PREVOST

WB24-25A

DATE :	July 2024	SECTION:	06 ELECTRICAL
EXPIRATION:	July 2026		
SUBJECT:	REPLACEMENT OF DECAL "REAR JUNCTION BOX COMPONENTS"

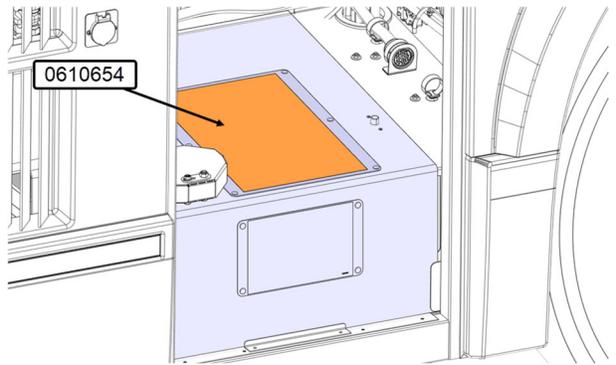
2. Remove the decal of the rear junction box components.

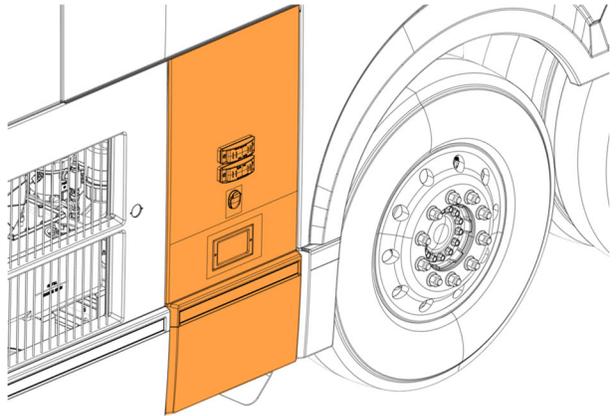
3. Install the new decal of the rear junction box components 0610654.
